# SERVICE BULLETIN

No. 697

Piper Aircraft Corporation

Subject: PA-31, PA-31-325 Takeoff Flaps

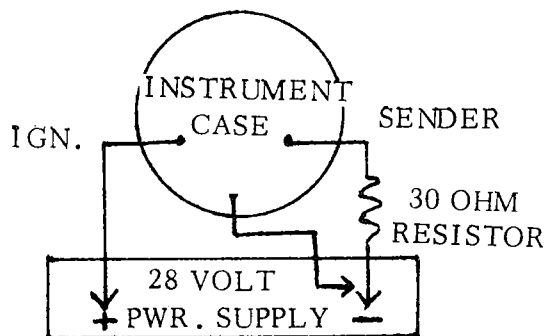
- A. For indicators of the AC or Rochester type Part Number 55650-2, 55567-2, 55991-3, and 55991-4, use the following instructions:
  1. Place indicator "face down" on a firm, protected surface.

- A.
  2. Use a standard slot head screwdriver (approx. 3/8" wide) and progressively work around the perimeter of the bezel until crimp is removed enough to allow the bezel and lens to be removed.
- CAUTION: Be very careful when removing and reinstalling the crimping of the bezel. Excessive pressure could crack glass lens or plastic instrument case.
3. Remove or cover up the words "TAKEOFF RANGE" with flat black paint that matches the instrument dial.
4. Inspect instrument for foreign material contamination.
5. Clean glass lens.
6. Reinstall bezel and lens.
7. Very carefully, work progressively around the perimeter and recrimp the bezel using the flat side of the screwdriver or a piece of hard wood. Check that the crimp is adequate to prevent lens rattle.
8. Check indicator calibration as follows:
